SERVICE LETTER NUMBER 123			
TITLE: QUEST KODIAK MODIFIED AXLE BEAM BUSHING			
BY: J. Sortor	AIRCRAFT MAKE/MODEL(S):	FLOAT MODEL(S):	NOTE(S):
APP: DG, KT	Quest Aircraft Design, LLC Kodiak 100	7000	OPTIONAL COMPLINACE S/L P/N 1005302 ECO 22499
DATE: 8/30/2011			
REV: A

This service letter applies to all S/Ns Wipline model 7000 amphibian floats, as installed on Quest Aircraft Design, LLC Kodiak 100 aircraft per FAA STC number SA02848CH.

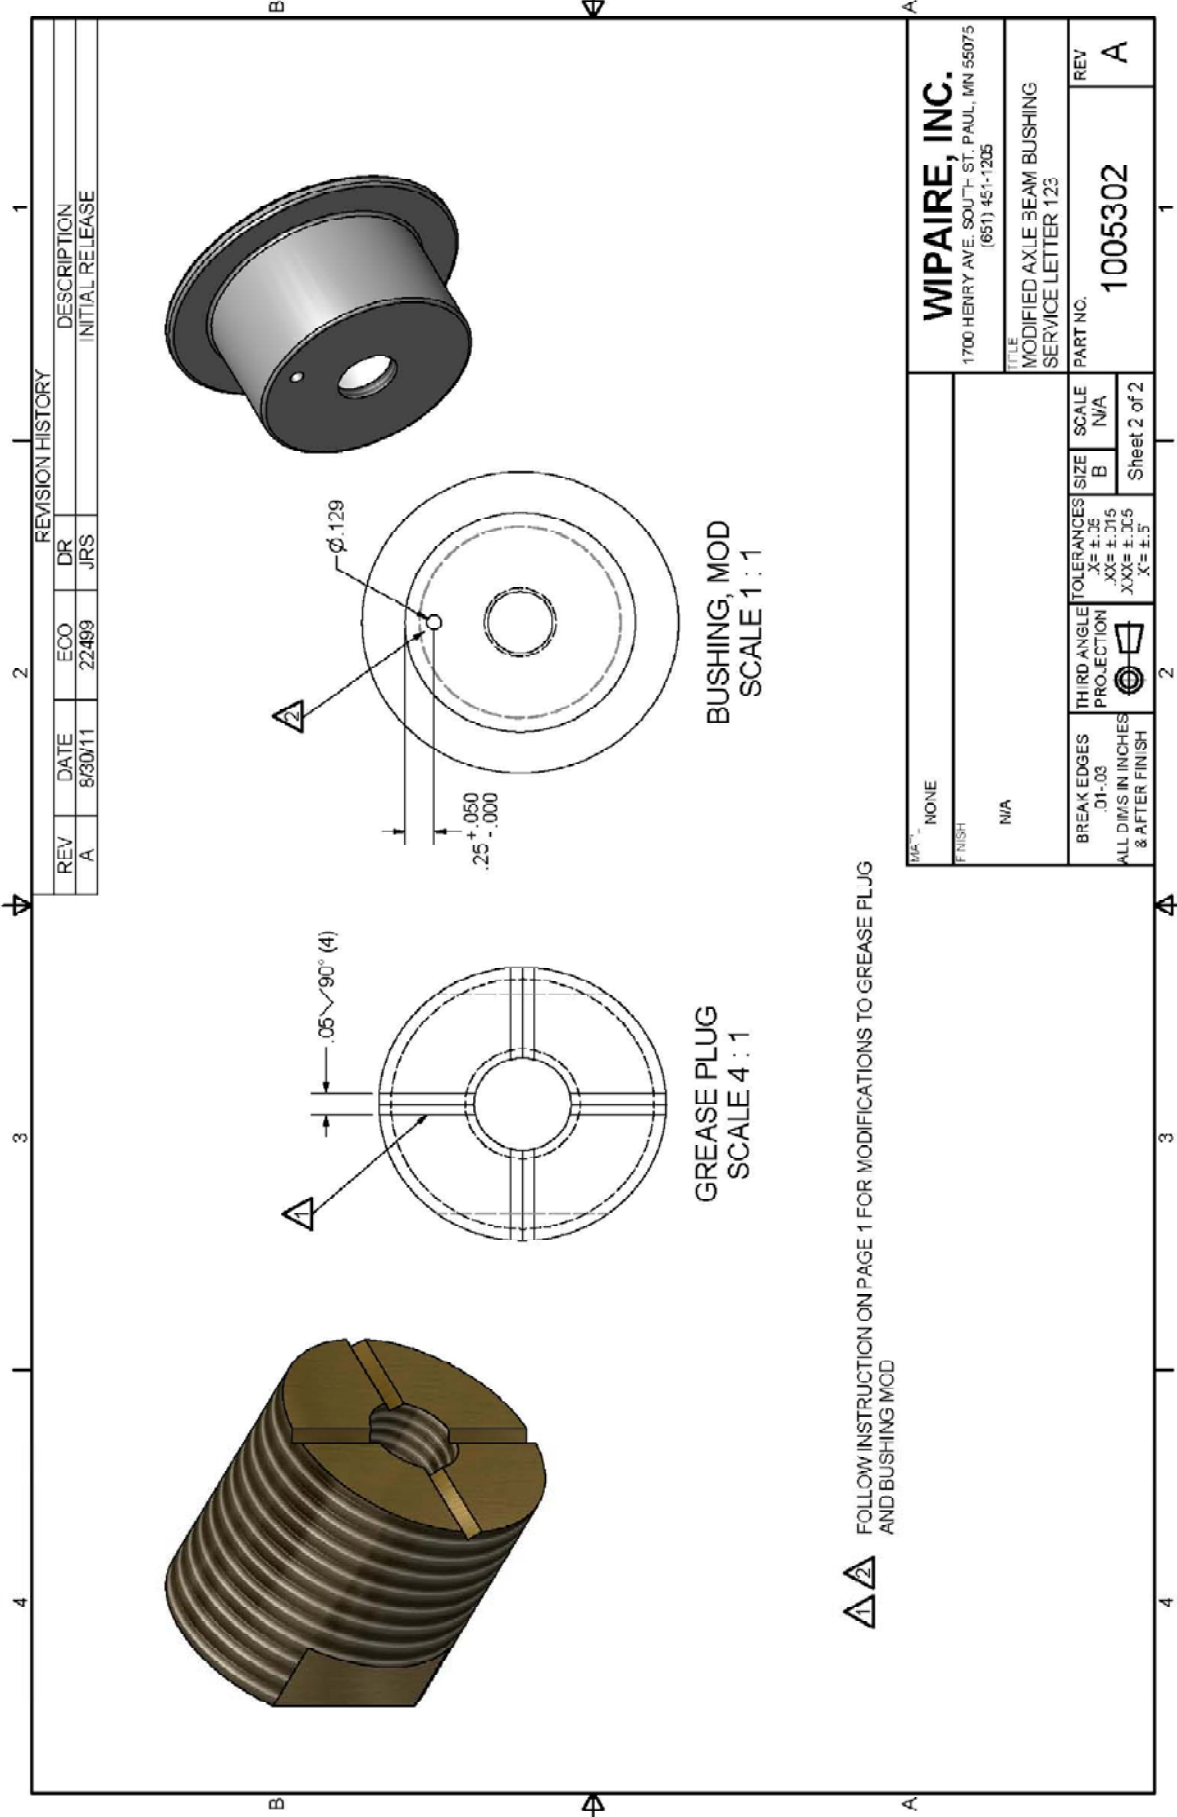
Wipaire has received reports that the some axle beam bushing grease zerks, when serviced with grease, have pulled the threads off of the brass plug in the main landing gear attachment bushing. This modification alleviates that condition and prevents damage to the threads.

1. CONFIGURE AIRCRAFT POSITION SAFE FOR MAINTENANCE.
2. RELIEVE AIRCRAFT WEIGHT FROM FLOAT STRUTS.
3. REMOVE LH AND RH STRUT FAIRING ASSEMBLIES.
4. REMOVE JAM NUT AND BRASS BUSHING WITH GREASE ZERK FROM PILOT SIDE FWD AND AFT BUSHING CAPS.
5. MODIFY BRASS PLUG BY USING A CUT-OFF WHEEL, CUTTING .060 WIDTH X .060 DEPTH CROSS HAIRS THRU END OF PLUG TO CHANNEL INTO BUSHING AREA.
6. ON PILOT FWD AND AFT BUSHING CAPS (SHOWN ABOVE) DRILL #30 HOLE IN FACE OF BUSHING USING DRILL STOP SET TO .180".
7. INSTALL BRASS PLUG UNTIL IT MAKES CONTACT WITH THE AXLE PIN AND BACK OFF 1/8 OF A TURN, SET JAM-NUT.
8. REPEAT STEP 4 AND 7 ON PASSENGER SIDE BRASS PLUGS AND BUSHING CAPS.
9. GREASE ALL BUSHING UNTIL GREASE IS VISIBLE FROM RELIEF HOLES.
10. REINSTALL LH AND RH STRUT FAIRING ASSEMBLIES.
11. MAKE LOG ENTRY IN MAINTENANCE RECORDS THAT WIPAIRE SERVICE LETTER 123 HAS BEEN COMPLIED WITH.

HOLES ARE FOR PURPOSE OF GREASE RELIEF AND DO NOT NEED TO BE CLEANED OF ALL DEBRIS AFTER DRILLING
